Curtin University

1. PURPOSE

This document provides a brief report outlining the results of visual inspection and first-line testing of the first two modified beam-former boards received from Brett Douglas of Convergence Engineering.

This report is designed to feed back the results of our inspection and testing so that Brett can possibly slightly modify his procedures, and continue re-working the remaining 98 beam-former boards.

FIGURE 1: GENERALLY OK

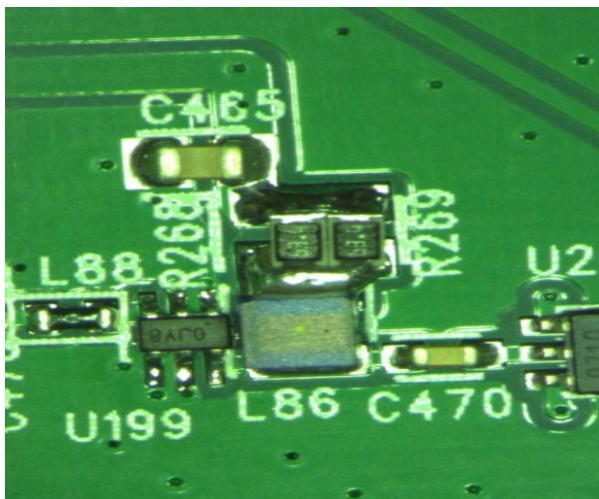
In general there appeared to be somewhat too much solder surrounding the two 63.4 ohm larger resistors and associated bias inductor that drive the input amplifiers in all 16 channels. This can be seen in the first photo shown overleaf, where the designators are R268, R269 and L86 respectively.

While this excess solder does not have any immediate effect, it could leave a frozen-in strain which might manifest as a broken joint after time in service particularly due to thermal cycling on site. CIRA would prefer if some means could be found to reduce the amount of solder used on these resistors.

FIGURE 2: RESISTORS OFFSET, STILL OK

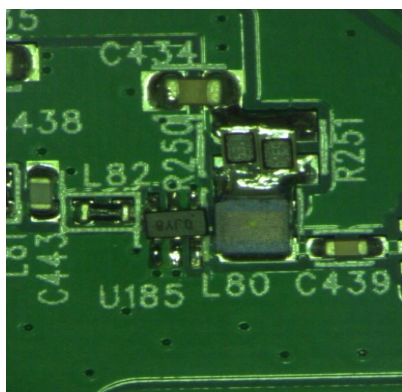
There were some cases where the resistors were partly offset with respect to each other and the underlying copper pads, and in one case (shown below right), the offset was far enough that the resistor was not properly connected. An example of an acceptable offset, and one where the offset was too far, are shown over the page.

FIGURE 3: RESISTORS OFFSET, R286 TOO CLOSE TO L93

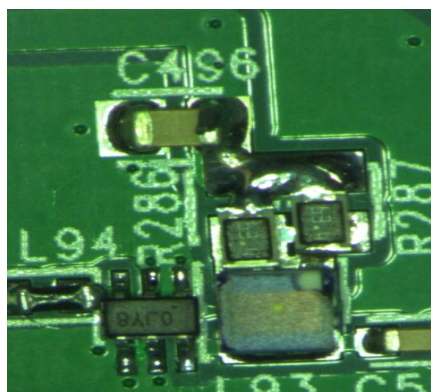
As can be seen in Figure 3 R286 has moved to be too close to the inductor, and the upper end does not make contact with the desired pad. In fact before this fault was rectified only R287 was

connected in circuit. We used a pair of Weller soldering tweezers to re-melt the solder and move R286 back into proper position, after which it made proper contact.

FIGURE 4: L28 MISALIGNED

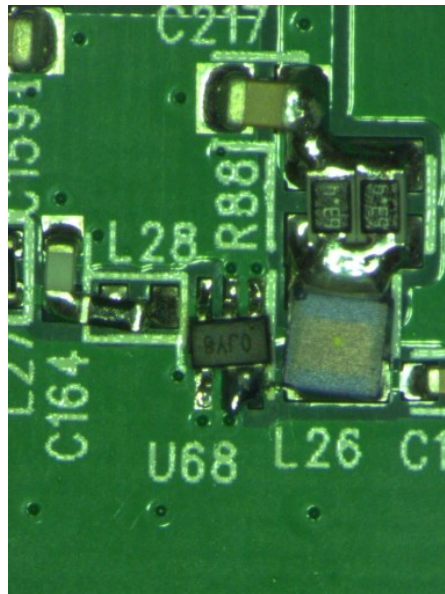
On several channels the input inductor has moved slightly from its original position (see L82 in Figure 2 on the previous page for an example of an inductor that has NOT moved). In the case shown below, the inductor had moved so far that it was no longer making proper contact, see L28 in Figure 4.

A short circuit between the output pin (pin 6) and ground (pin 5) on the lower side of U68 is also visible in Figure 4 above. This fault would also have been detectable using the multimeter test. Therefore, while unlikely, had the fault remained into power-up testing it would have prevented one of the 5V rails from powering up, potentially damaging the supply.

Again, we used Weller soldering tweezers to correct this fault in a matter of seconds.

Similar to the other issues, this fault was quickly rectified using a regular pencil soldering iron and solder-wick braid.

FIGURE 5: 'DRY' SOLDER JOINT ON PIN 2

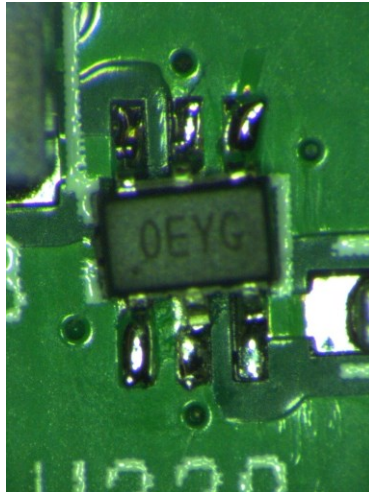
As can be seen over the page in Figure 5 overleaf, the solder has failed to ‘wet’ the lower central ground pin of U229 (pin 2) and while it is in physical contact with the pad, it may not perform correctly at RF frequencies and could become isolated at a later time due to corrosion/oxidation of the contact surfaces.

This took a little more effort to correct due to the massive copper ground plane rapidly conducting away soldering heat. However re-work flux and a freshly cleaned pencil tip soldering iron were able to re-flow the solder to make a proper contact.

FIGURE 6: 'FLOATING' PIN 2

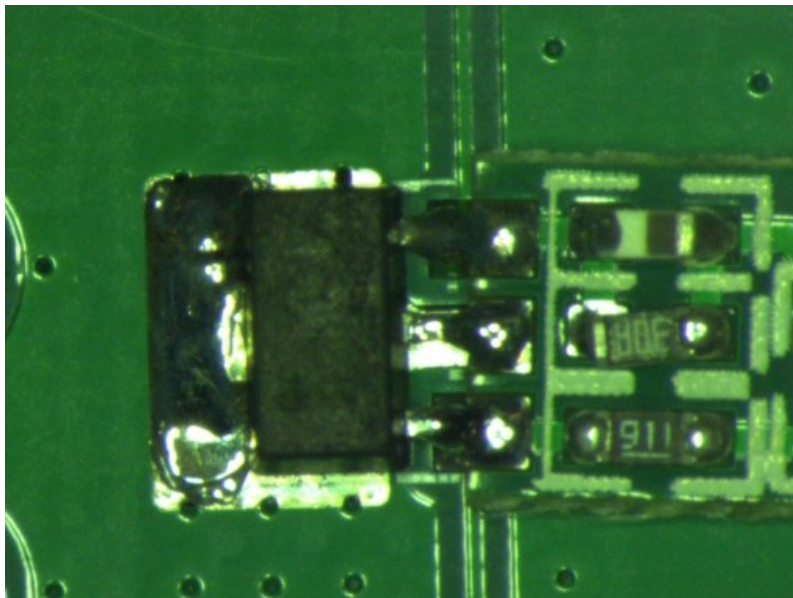
On both beam-former boards, it was observed that while the stabilisation daughterboard was well soldered onto the three device pins, the middle or ground pin of the device was not soldered to the pad on the main board. See below.

It is uncertain if this could have any RF performance issues particularly at higher frequencies and for long-duration observations where even the tiniest amount of systematic or internal noise can be integrated up to a point where it dwarfs the desired signal.

Therefore we would prefer if the centre pin was also soldered to the main board before the daughterboard was attached.

Addressing this issue took approximately five minutes per board, since we had to use an under-board hot-air source to bring the general board area close to soldering temperatures, and a hot-air pencil from the top to actually melt the solder. We then removed the daughterboard temporarily and used a pencil iron and re-work flux to 'wet' the remaining solder from pin 2 onto the pad on the main board. We then used solder-wick braid to remove excess solder from the ends of the other two pins of the QPB device, and from the castellated vias on the daughterboard. Finally we soldered the daughterboard back into place using a pencil iron and wire solder.
